ADDENDUM NO. 1

VILLAGE OF NEW BREMEN Eastmoor Drive and Front Street Reconstruction

December 14, 2017

Re: Village of New Bremen
Eastmoor Drive and Front Street Reconstruction

DETAIL OF CURB INLET SEDIMENT CONTROL DEVICE
WITH CURB FILTER

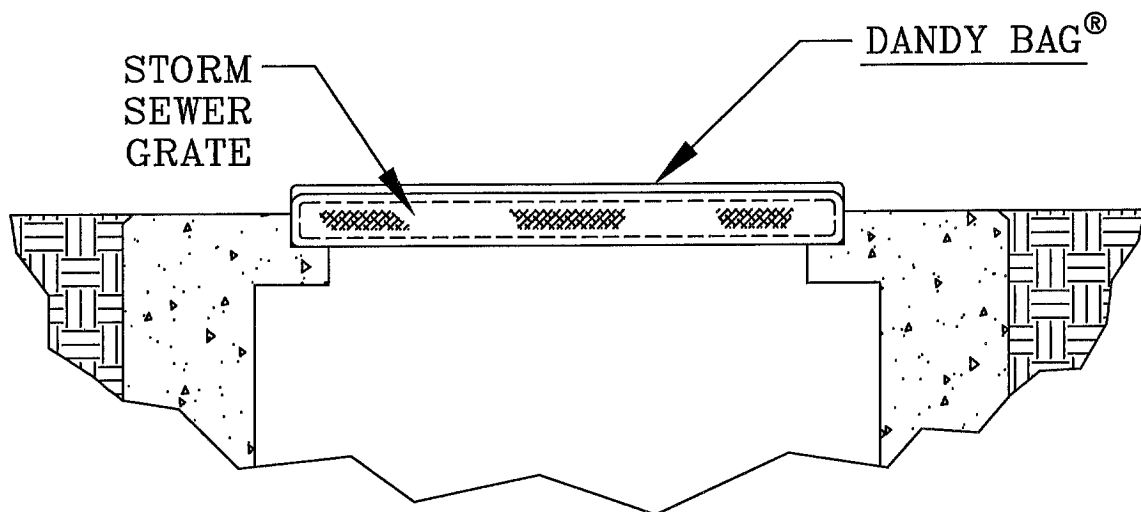
5. Erosion Control – A lump sum bid item has been added for erosion and sediment control to the Base Bid and the Alternate Bid. This work shall include inlet protection such as Dandy Curb” or “Dandy Bag” as per the attached details.
